Redesign / Phase-Out

Launch of new control cards Delcon-2 for lift control valves

Comparison of hardware

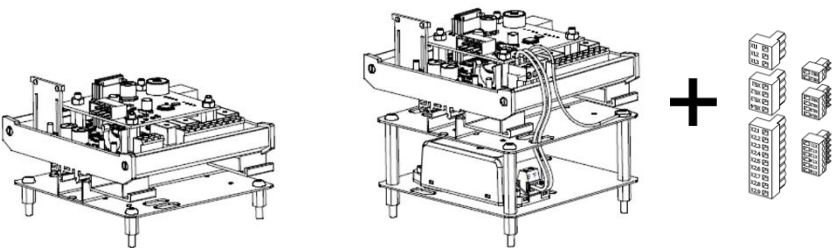
Our existing Delcon control cards for lift control valves have been completely revised. The new generation is called Delcon-2 and will be rolled out gradually starting in August 2025. As part of this changeover, the previous Delcon control cards will be removed from the product range.

- The ground plane area of the Delcon-2 electronics is identical to that of the NTA-2 – fits directly into the existing elevator control system when replaced
- Compatibility with handheld terminal and computer interface
- Menu navigation and parameterization identical to previous Delcon

- Uses the same basic hardware as iCon-2 (with up-to-date electronic components)
- Data logger function via USB interface
- Power supply with 24 VDC (optional: ground plane with power supply; available with input range 85 ... 305 VAC if no 24 VDC is available or power is insufficient)
- Standard integrated option for electric emergency lowering with 24 VDC battery
